⚠3 ADDENDUM #3

THE WICHITA AIRPORT AUTHORITY
COLONEL JAMES JABARA AIRPORT

LIFT STATION AND MECHANICAL DETAILS

SANITARY SEWER AND WATER DISTRIBUTION SYSTEM
SOUTHWEST AREA SITE DEVELOPMENT IMPROVEMENTS

PUMP SCHEDULE ADD. #3

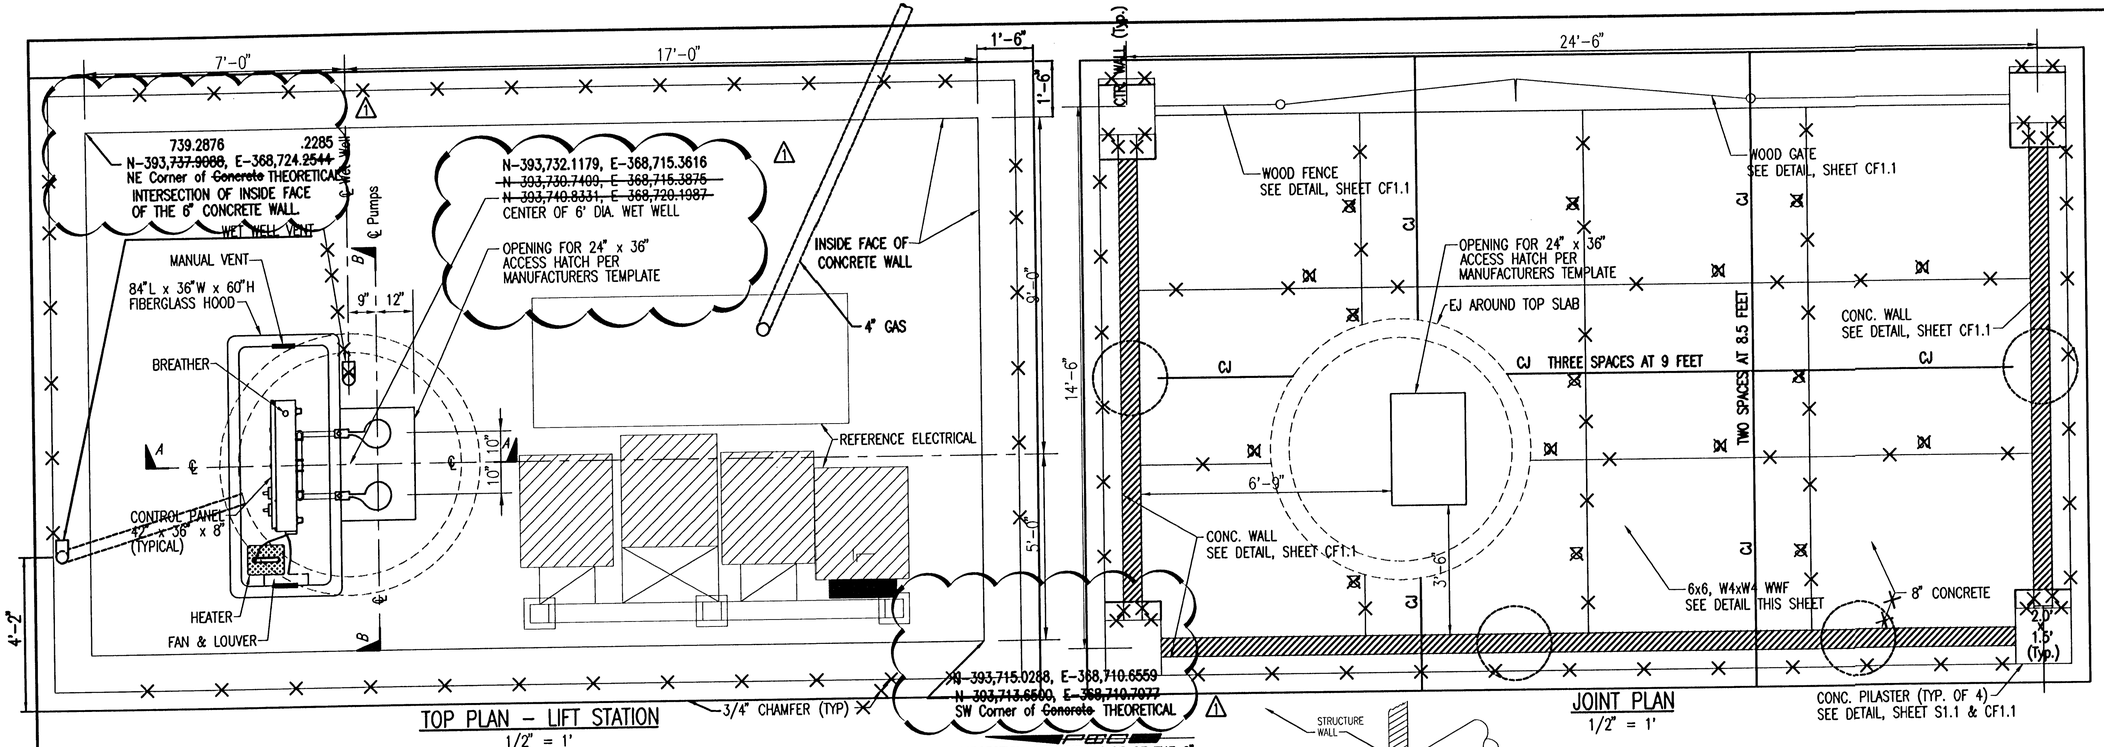
MARK	TYPE	STATUS	GPM	FT. HEAD	EFF. %	HP	RPM	ELECT.
P-1	SUBMERSIBLE	PROPOSED	~~150~~	~~140-42~~ 37	~~70~~ 45	5	1800	230/60/1
P-2	SUBMERSIBLE	PROPOSED	~~150~~	~~140-42~~ 37	~~70~~ 45	5	1800	230/60/1
